STATE OF NEW MEXICO  
**ENERGY AND MINERALS DEPARTMENT**  
OIL CONSERVATION DIVISION  
HOBBS DISTRICT OFFICE

SUBJECT: Exception for packer setting depth on  
West Dollarhide Drinkard Unit #73-N 33,T24S, R38E

RE: WEST DOLLARHIDE DRINKARD UNIT WELL NO. 73  
SECTION 33, T-24S, R-38E UNIT LTR. N  
LEA COUNTY, NEW MEXICO

GETTY OIL COMPANY  
WEST DOLLARHIDE DRINKARD UNIT  
WELL NO. 73

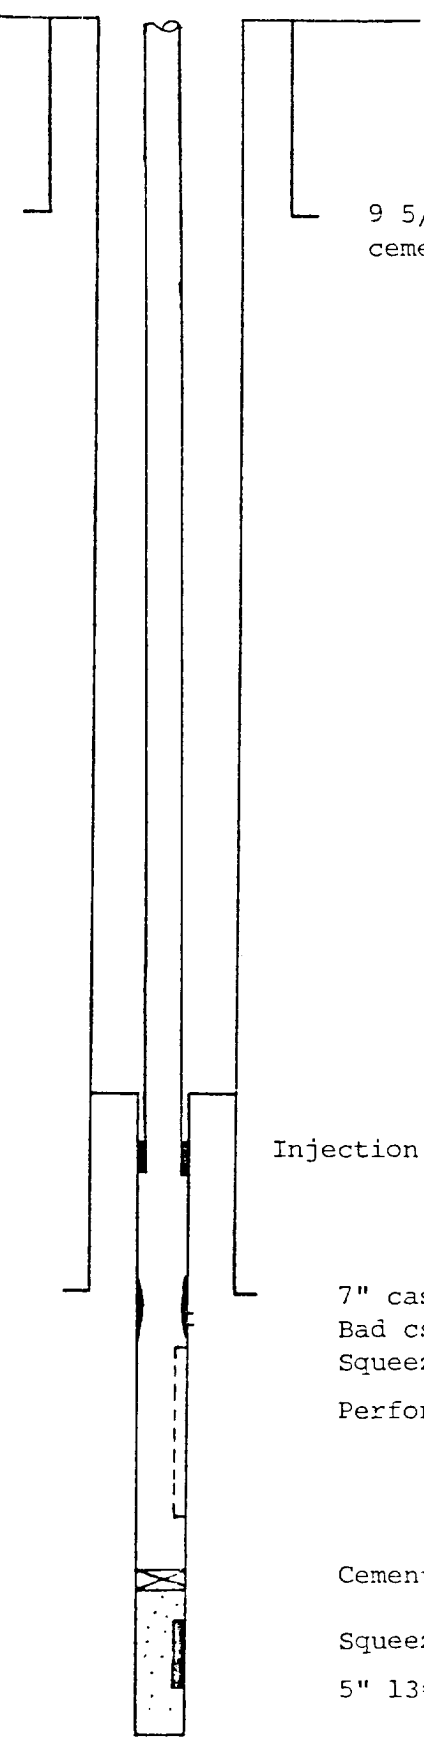
To prevent future downhole mechanical problems with setting of the injection packer within 100 feet of the top perforation, we are requesting approval to set the injection packer at 6200'. Prior to running of the 5" liner in March 1971, water was being injected into the open-hole section 6249-6850', which includes the Tubb, Drinkard, and Abo formations. All three formations are in the unitized interval. Presently, we are attempting to isolate injection into the Drinkard due to early water breakthrough with the Abo and Tubb formation.

The injection packer will be 327' above to upper most Drinkard perforation. As with other wells that have similar downhole problems, an injection profile will be run within 3 months and yearly thereafter.

We request your immediate attention to this matter, as the workover is in progress. We seek approval to set the packer above the squeezed casing leak in the Tubb when we return this well to injection.

Your request for an exception to our requirement that packer be set within 100 feet of uppermost injection perforation in the WDDU #73 is hereby granted.

According to your proposal the injection packer will be set at approximately ~~6073~~ <sup>6200</sup> feet.

If injection profiles indicate upward channeling the exception may be rescinded.
